## ADDENDUM NO. 2

**PROJECT NAME:** NCTA Vet Tech Roof Replacement  
**UNL PROJECT NUMBER:** CU33P010  
**BID INVITATION NUMBER:** 2177-13-7215

**DATE OF ISSUANCE:** 11 June 2013  
**DATE OF BID OPENING:** 26 June 2013

**5 REVISED MECHANICAL CURB DETAIL**  
 SCALE: 1 1/2" = 1'-0"

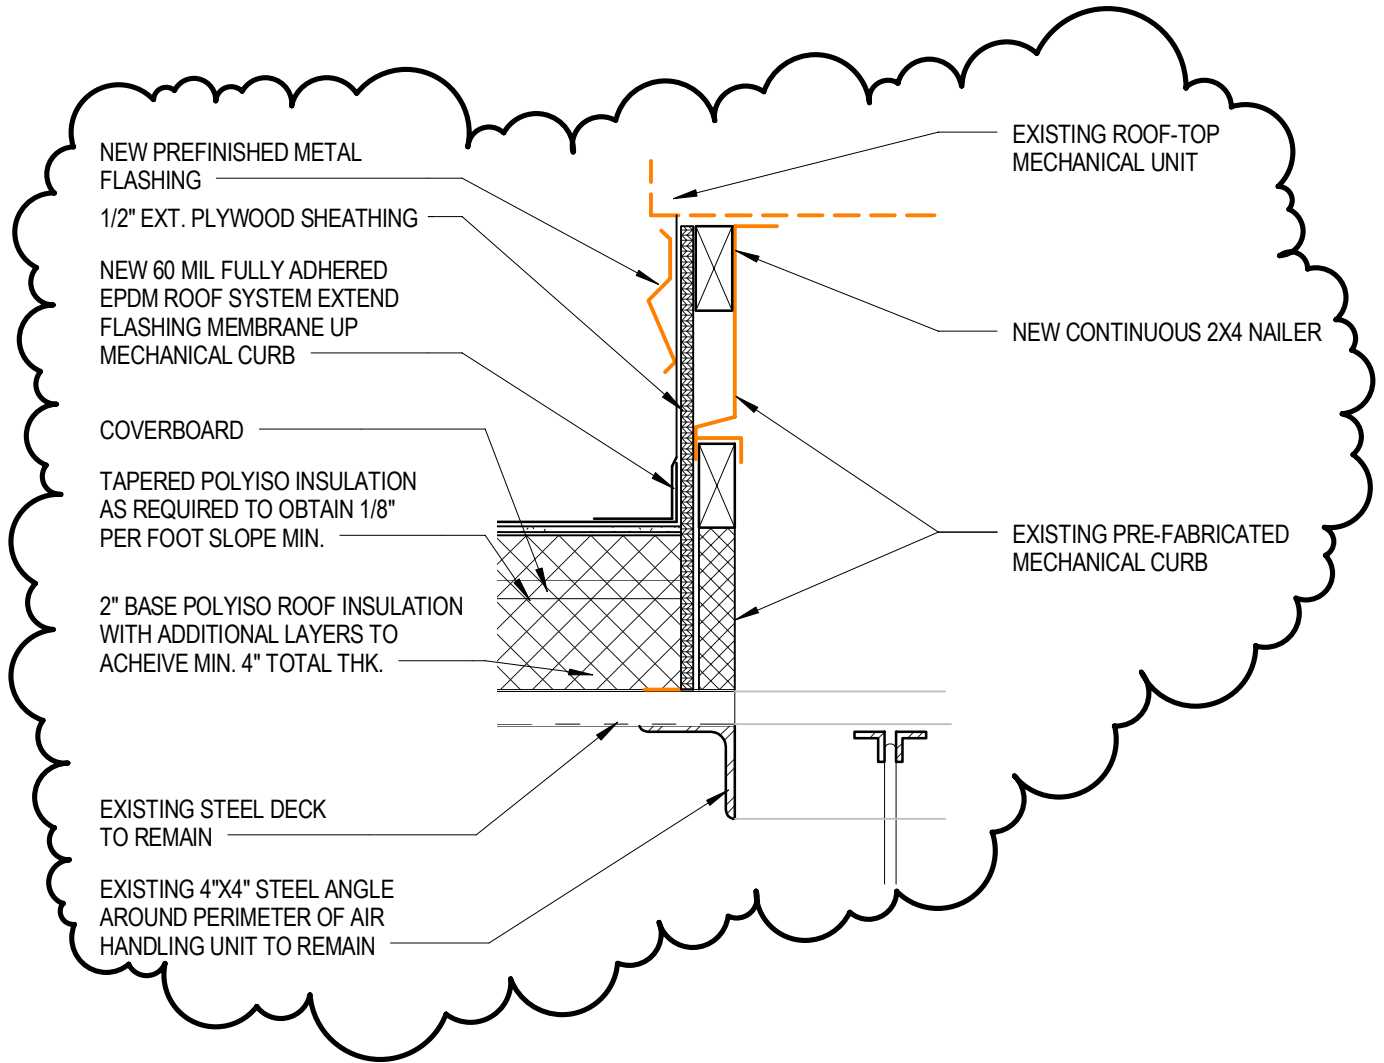
**Item 2-9: A1.2 – ROOF PLAN AND ROOF DETAILS**

Refer to detail 5 NEW MECHANICAL CURB DETAIL. Replace detail with attached supplemental drawing SDA-001.
